Working Party on Lighting and Light Signalling (GRE)

**Regulations Nos. 3, 4, 6, 7, 19, 23, 38, 65, 69,
70, 77, 87, 91, 98, 112, 113, and 119**

Proposal for Supplement 3 to the 01 series of amendments to Regulation No. 119 (Cornering lamps)

Submitted by the expert from Germany*

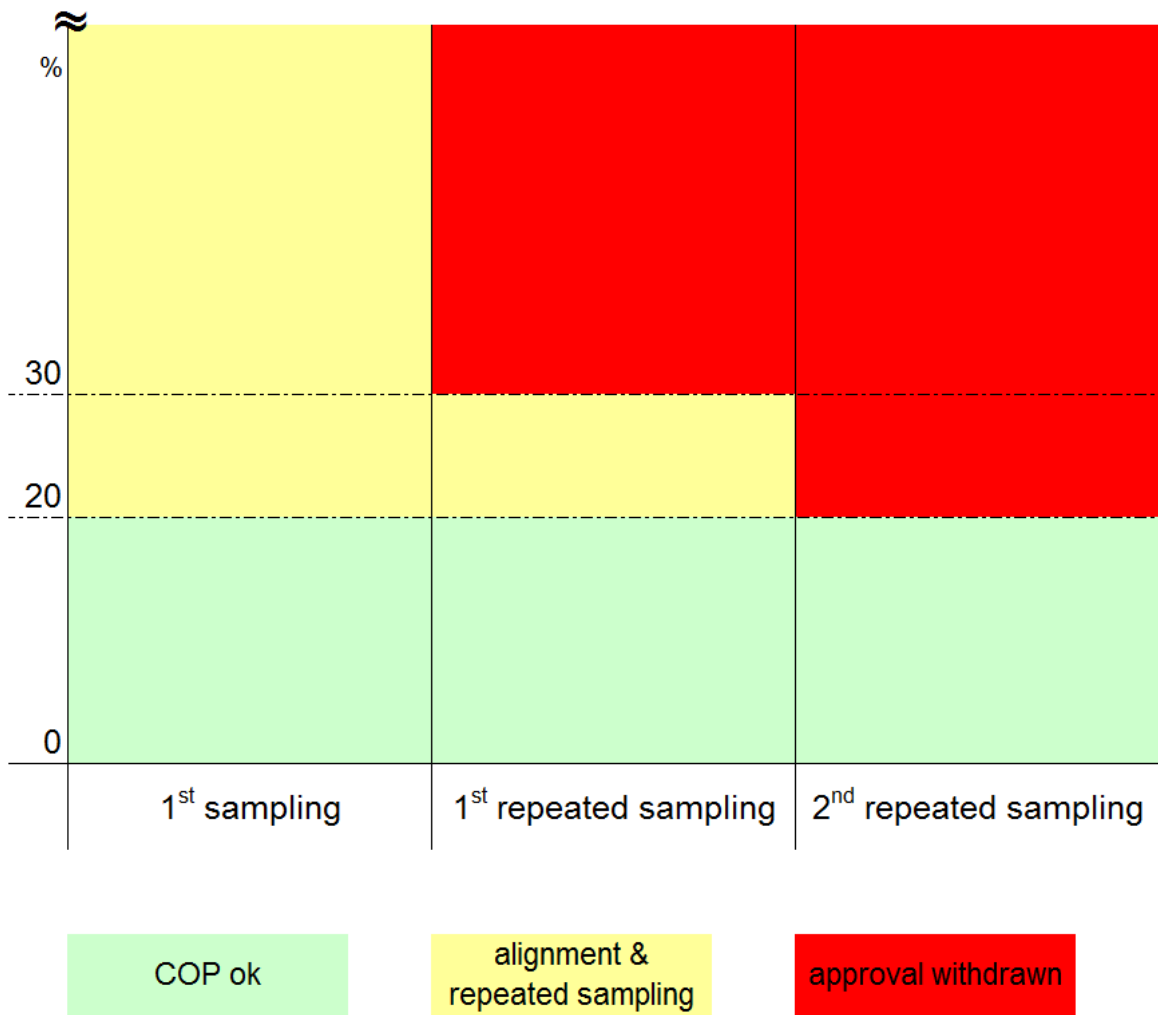
6. CoP is now described in a clear structured stepwise process (with limited steps), which gives the manufacturer the chance in the first step - in the case of deviations of more than 20 per cent - to align his production process. Also, the CoP process can be completed earlier when the first two samples are in the full specifications.

7. The proposal details the "third step" which defines the condition where the approval shall be withdrawn, when after the second repetition of this process the manufacturer was not in the position to "align" his production process in the correct way.

8. The attached drawing shall demonstrate this stepwise process.
